# SB-10058488-4298

SI B65 02 15 Audio, Navigation, Monitors, Alarms, SRS June 2015 Technical Service

This Service Information bulletin supersedes SI B65 02 15 dated January 2015.

**SUBJECT** iDrive Controller Trim Peeling

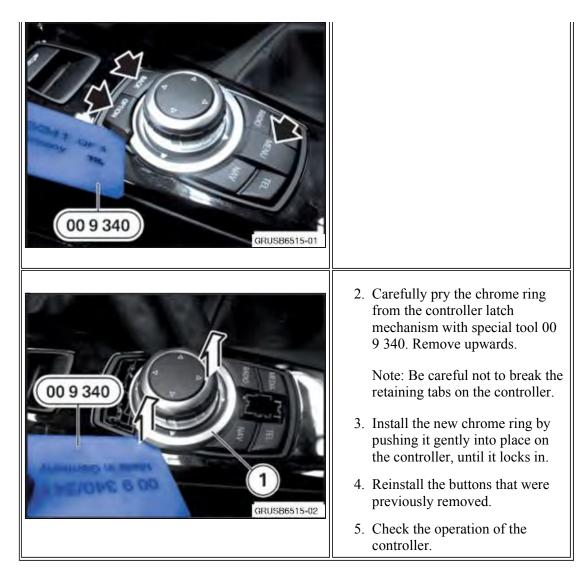
**SITUATION** The chrome ring on the iDrive controller is peeling.

**CAUSE** Poor chrome material adhesion

**CORRECTION** Only replace the chrome trim.

Do not replace the complete iDrive controller for this issue.

Replace the iDrive controller trim piece per ISTA Repair Instruction 6131198, "Replace controller chrome ring." The instructions are included in this Service Information bulletin.
